## Part 2 – Technical Requirements

Application under the *Agricultural Operation Practices Act* for a confined feeding operation, manure collection area, and/or manure storage facility(ies)

Proposed facilities	Dimensions (m) (length, width, and depth)
FEEDLOT PENS            (consists of 2 rows with 5 pens each)	304.8M X 103.6M (total)
SICK PENS, SHIPPING & RECEIVING PENS	60.9M X 103.6M (total)
PROCESSING BARN	24.3M X 36.6M
AO note: applicant is also proposing a runoff catch basin: 103.6 x 60.9 x 2 m deep

AO note: no existing CFO facilities are located on the LLD in which the proposed feedlot is to be constructed.

Aerial photo added by AO

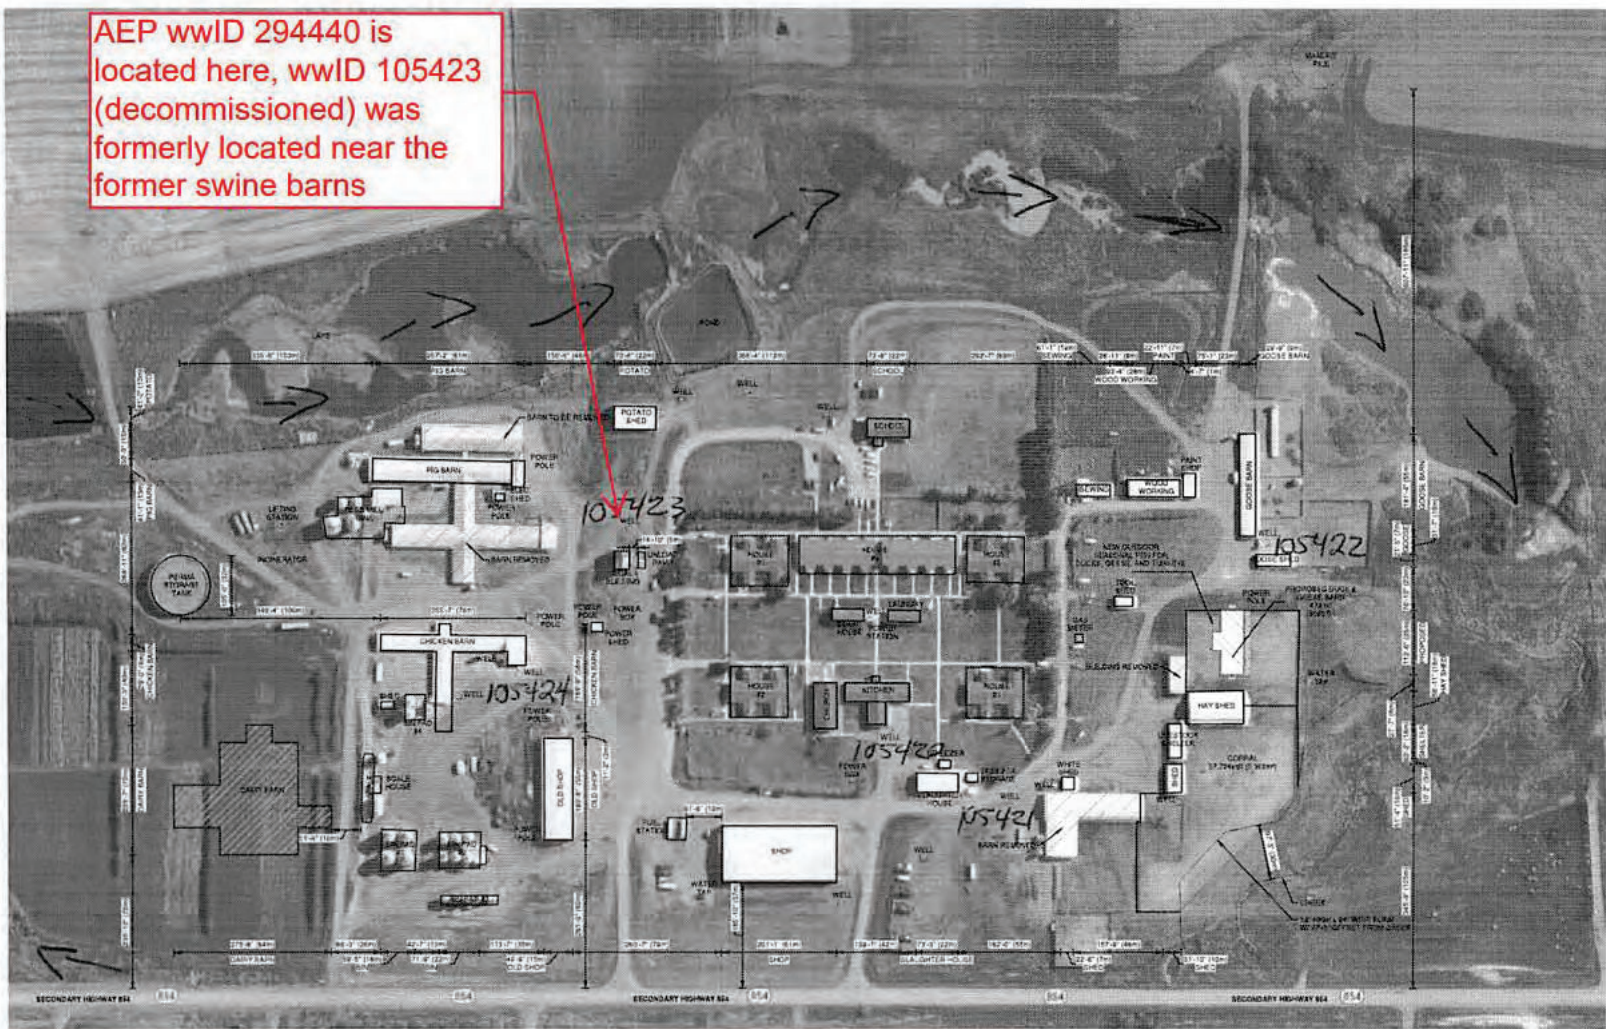
AO note: WWID 105503 is the closest well to proposed facilities; all other wells listed are located further away.
